Peer Review of Flood Modelling undertaken for the Macintyre River Floodplain

Inland Rail Project
North Star to Queensland Border (NS2B)

Goondiwindi Regional Council

1283-02-D1, 27 November 2020

Figure 6-1 - Comparison of GEV and LPIII flood frequency distributions for Ottleys Creek at Coolatai (source: BOM Water Data Online)

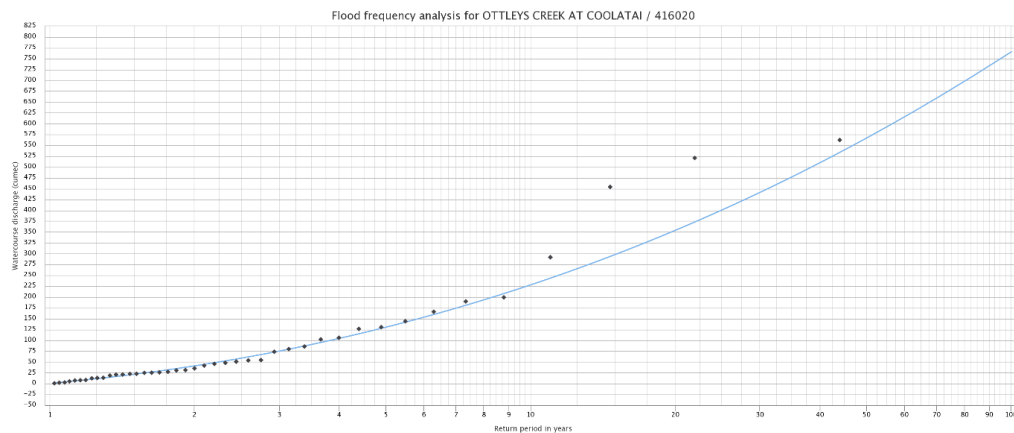
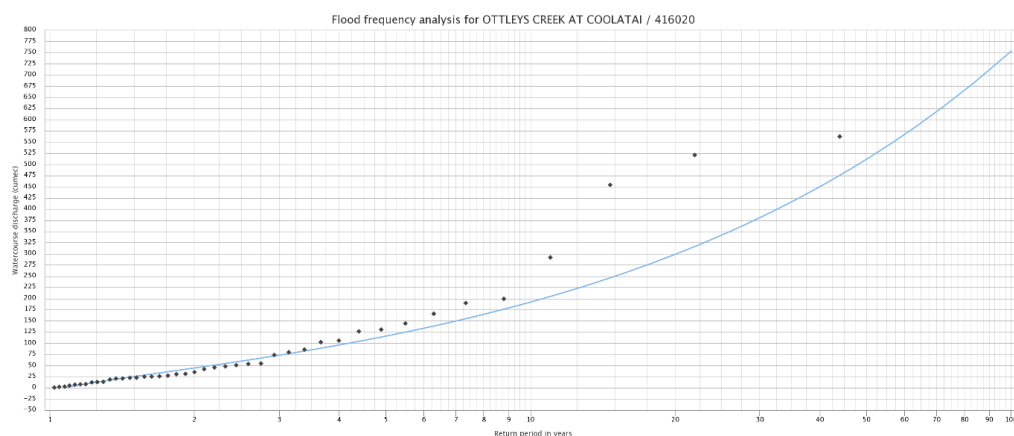
- The GEV and LPIII distributions provide similar results only for Ottleys Creek at Coolatai (see Figure 6-1);
- For the Macintyre River at Holdfast, the LPIII discharges are about 21% and 15% respectively higher than the GEV discharges for the 2% and 1% AEP events (see Figure 6-2);
- For the Dumaresq River at Roseneath, the LPIII discharges are about 22% and 23% respectively higher than the GEV discharges for the 2% and 1% AEP events (see Figure 6-3); and
- For the Macintyre Book at Booba Sands, the LPIII discharges are about 16% and 5% respectively higher than the GEV discharges for the 2% and 1% AEP events (see Figure 6-4);

Figure 6-4 - Comparison of GEV and LPIII flood frequency distributions for Macintyre Brook at Booba Sands (source: BOM Water Data Online)

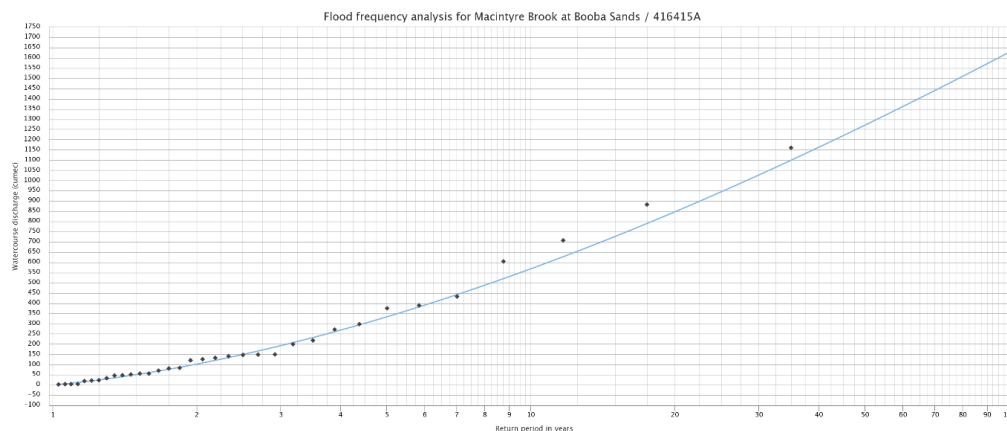
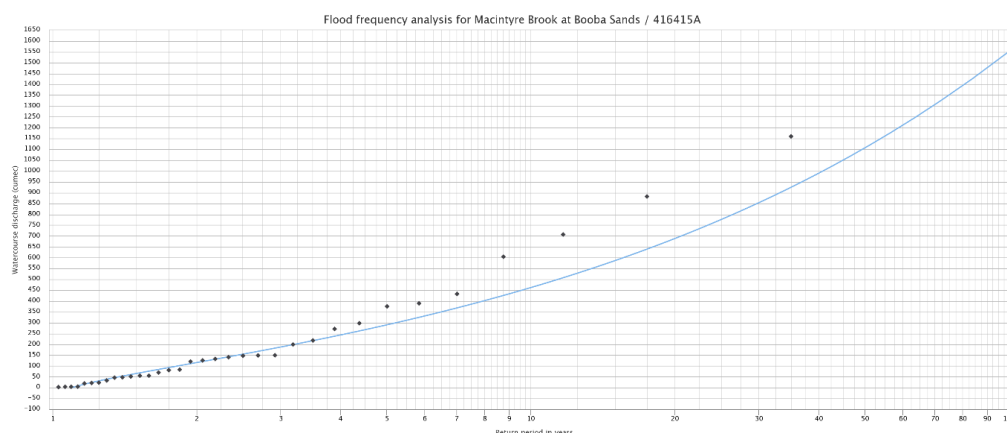
- The plotted modelled design 1% AEP discharge for Macintyre Brook at Booba Sands does not appear to be correct. The plotted value in Appendix H (Figure 8.1) is about 1,100 m³/s whereas the URBS model predicted value is 2,278 m³/s.
- The plotted 1996 flood discharge in Appendix H (Figure 8.5) for the Ottleys Creek at Coolatai should be larger than a 2% AEP after the required correction for the incorrectly plotted recorded discharges in Appendix H (Figure 7.6).

Figure 7-1 - Adopted local inflows along Strayleaves Creek, 1% AEP, 12 hours design event

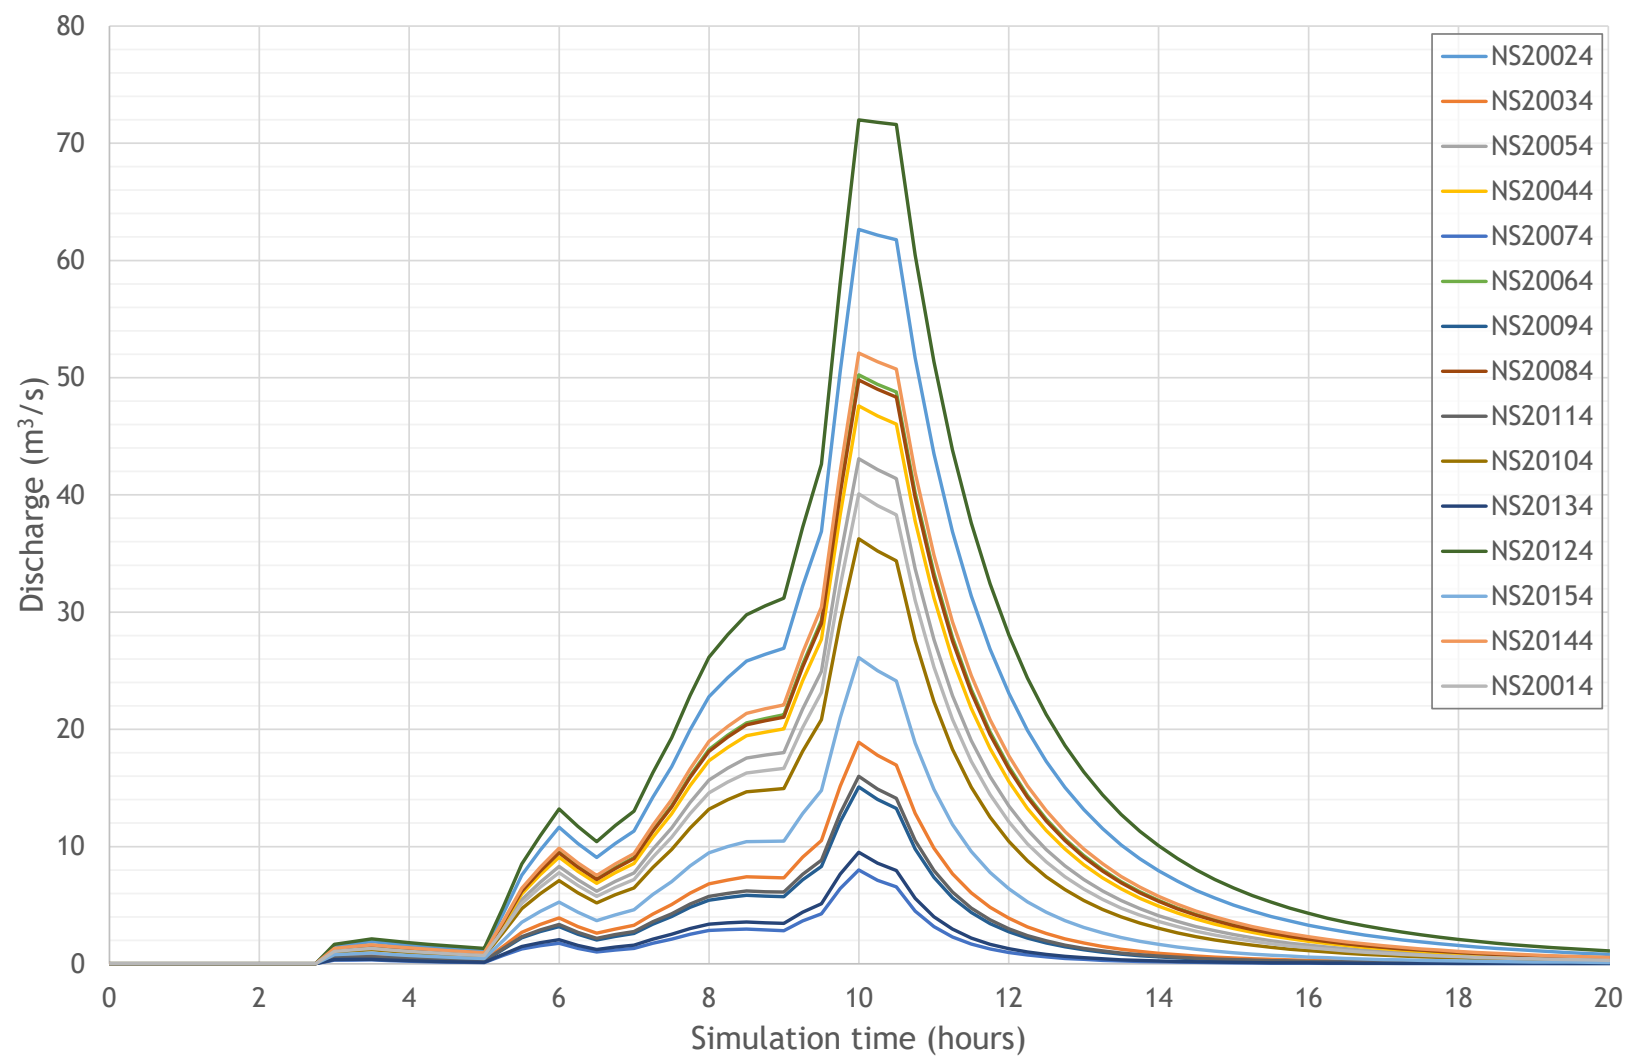
For Forest Creek and Strayleaves Creek, all adopted local inflows appear to be a scaled version of each other, with the same hydrograph shape and timing at all inflow locations along these creeks as shown in Figure 7-1. It also appears that the same inflow has been incorrectly allocated to two locations (labelled NS20024) along Strayleaves Creek as shown in Figure 4-5.

be similar and be proportional to the sub-catchment area. They have also noted that the local inflows applied to the hydraulic model only have a small degree of routing through the URBS model. I note that, based on the adopted subcatchment inflow hydrographs shown in Figure 7-1, no subcatchment routing is apparent.

In response to one of my queries, FFJV have stated that, with regards to the Forest Creek and Strayleaves Creek inflows, the same rainfall depth information and temporal patterns are applied to each of the URBS model sub-catchments. Therefore, the subarea runoff will

Figure 7-2 - Differences in modelled peak flood levels between the 1976 event and the 1% AEP design event

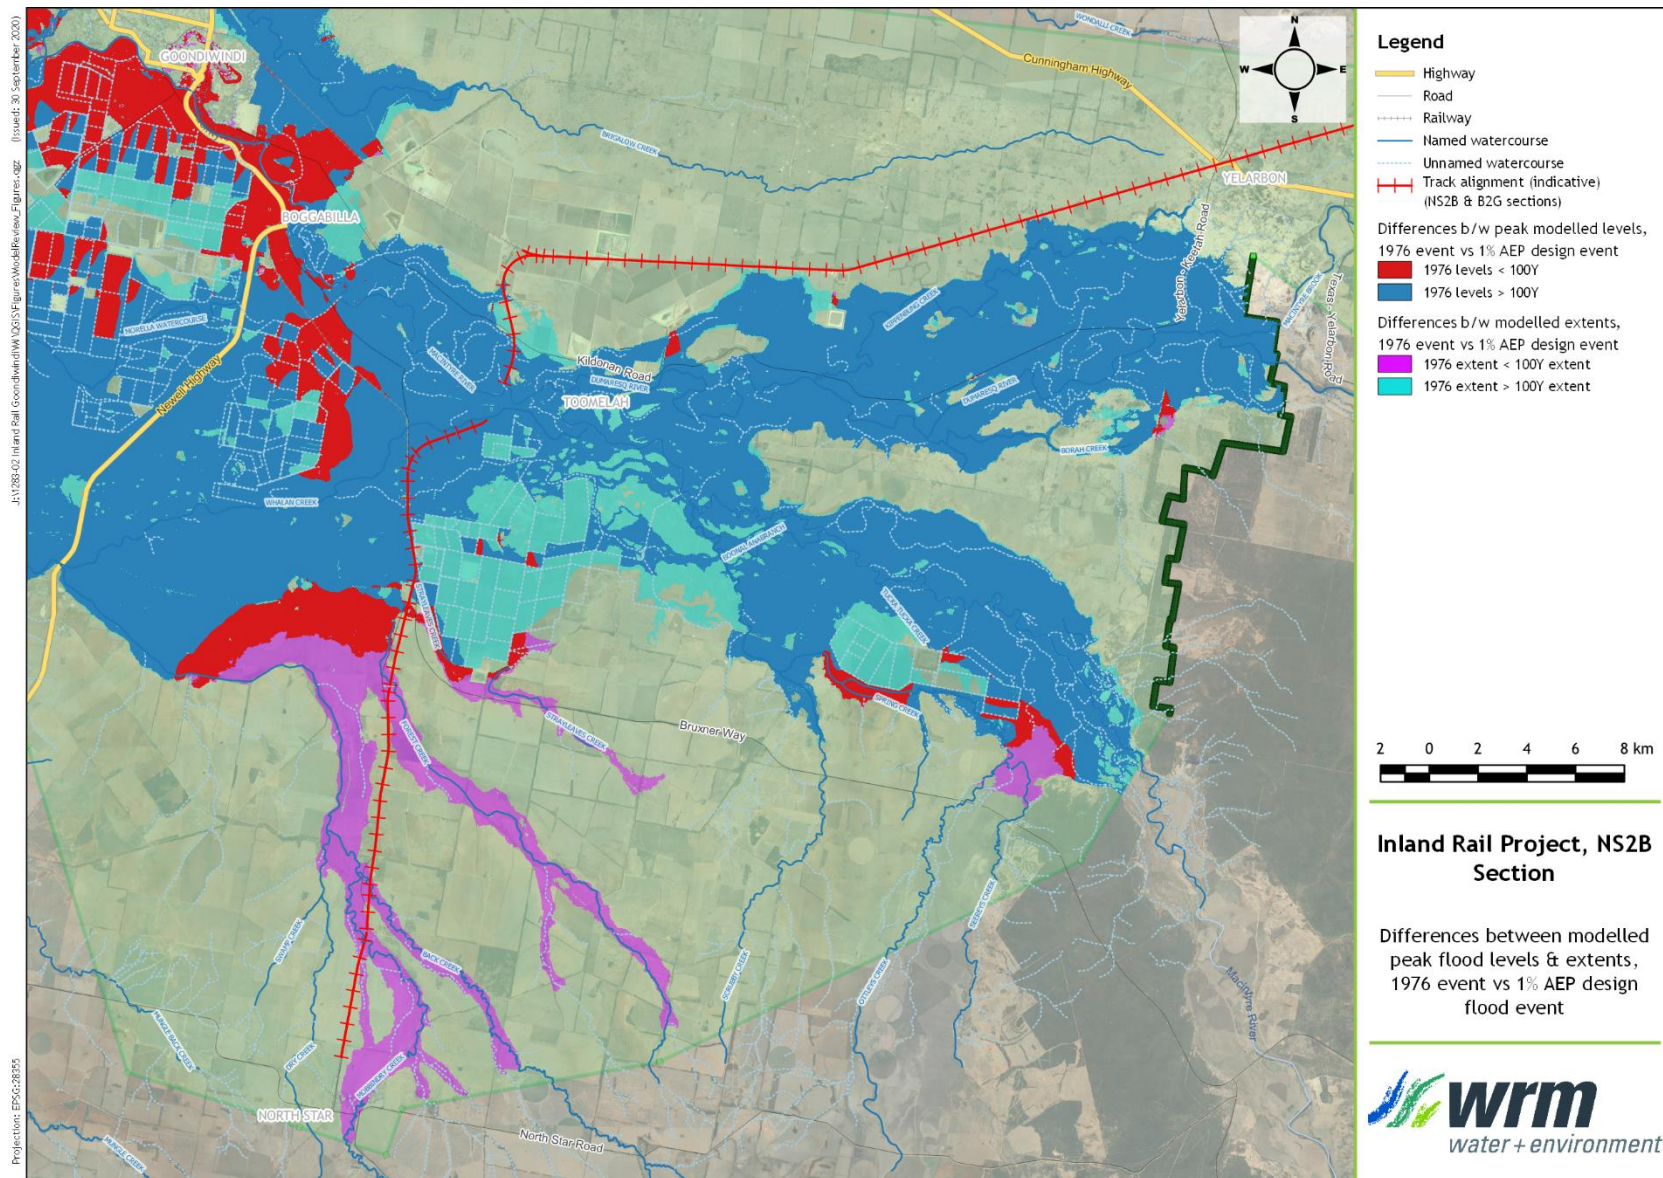
Figure 7-2, Figure 7-3 and Figure 7-4 show a comparison of the modelled February 1976, January 1996 and January 2011 event peak flood levels with the modelled 1% AEP peak flood levels. These figures show some apparently significant inconsistencies between the modelled historical flood event and the modelled 1% AEP design event results.

- The 1976 peak flood levels are expected to be higher than the 1% AEP peak flood levels because the 1976 event has been determined to be between a 1 in 200 and 1 in 500 AEP event. However, for the Macintyre River reach between Boggabilla and Goondiwindi, parts of the floodplain between the Newell Highway and the proposed rail corridor and the Ottleys Creek floodplain, the modelled 1% AEP peak flood levels are higher than the 1976 peak flood levels (see Figure 7-2). The reasons for this apparent inconsistency are not explained.

Figure 7-3 - Differences in modelled peak flood levels between the 1996 event and the 1% AEP design event

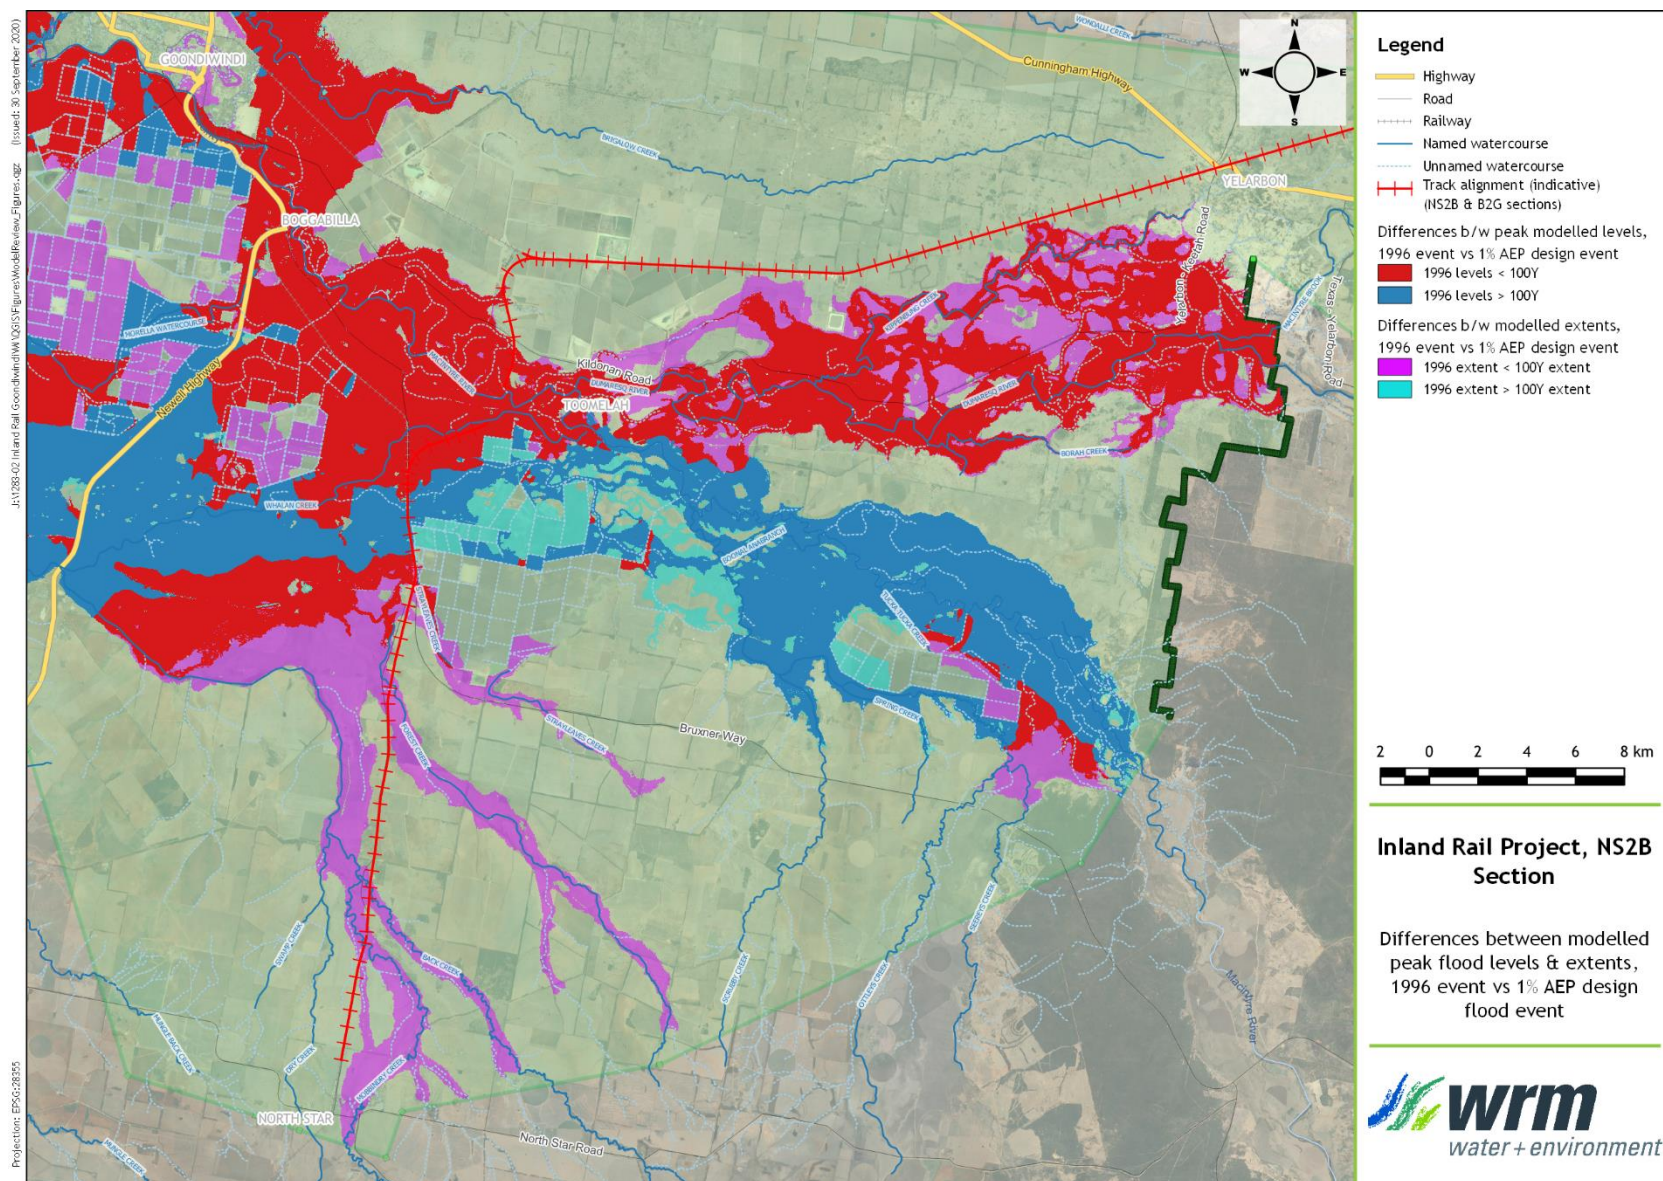
- The 1996 peak flood levels are expected to be lower than the 1% AEP peak flood levels because the 1996 event has been determined to be between a 1 in 30 and 1 in 50 AEP event. However, for the Macintyre River upstream of its confluence with the Dumaresq River including Ottleys and Scrubby creeks, and a significant part of the Whalan Creek floodplain, the modelled 1% AEP peak flood levels are lower than the 1996 peak flood levels (see Figure 7-3). The reasons for this apparent inconsistency are not explained. Again, the impact on modelled flood levels along the minor
